MAS004236 RU 24-19

Rapid Update 726 Grecale – “Door to body” Connector taping

DATE: July 15, 2024

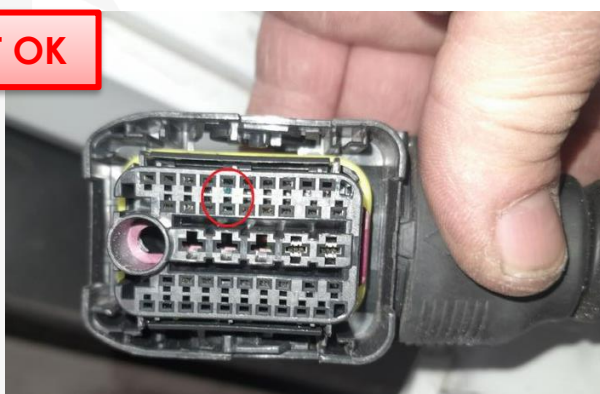
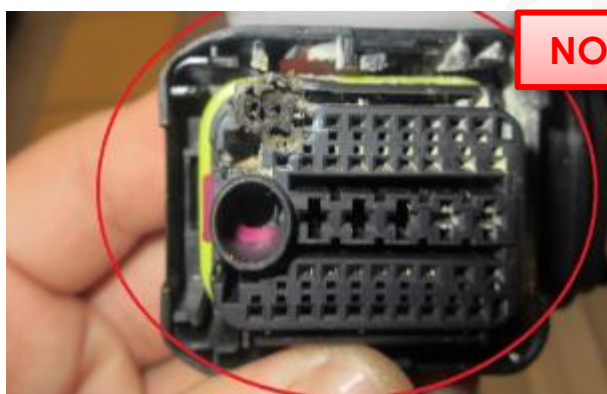
Certain Maserati Grecale MY23 MY24 listed in MODISCS+ are involved in a Rapid Update to add extra protective tape to both rear "Door to body" connectors.

Some vehicles may have been fitted with a protective weather seal boot on the body-to-door connectors that may not ensure proper insulation against moisture infiltration. To address this, a rework has been devised: taping the boot to the connector to prevent any potential moisture infiltration.

The procedure described in this bulletin involves sealing the protective rubber boot using a specialized **self-amalgamating ethylene-propylene tape** (commonly known as "rescue tape" not electrical tape) as shown below.

1. Always check ModisCS+ to see if the vehicle is involved in this action and if it has not been previously performed.
2. Disconnect the battery according to the instructions in the workshop manual:
 - a. **08.20.001 - BATTERY - Connecting/disconnecting the electrical power supply**
3. Identify the connectors to perform the rework. It is located in the internal area of both left and right rear doors.

5. Remove the rubber wire cover/boot and check that there are no **obvious signs** of corrosion on the terminal pins (see examples below).

6. If there are evident signs of damage to the connector, corrosion on a single or multiple terminal female pin, or if the customer has reported malfunctions related to this connector, open a BlueOnline as "Support Request" and wait for further instructions.
7. If there are no signs of damage to the connector or female pins. Continue with the rework:
8. With the connector disconnected from the vehicle, adjust the protective rubber boot so that it is properly fitted to the plastic exterior of the connector as shown below. Next, use a strip of **"self-bonding tape"** approximately 6-8 inches in length and tightly wrap the rubber boot to the connector. To ensure a tight seal, slightly stretch the tape so that half of its width contacts the boot and the other half contacts the connector during the initial wrap. Continue wrapping, finishing with at least two complete loops.
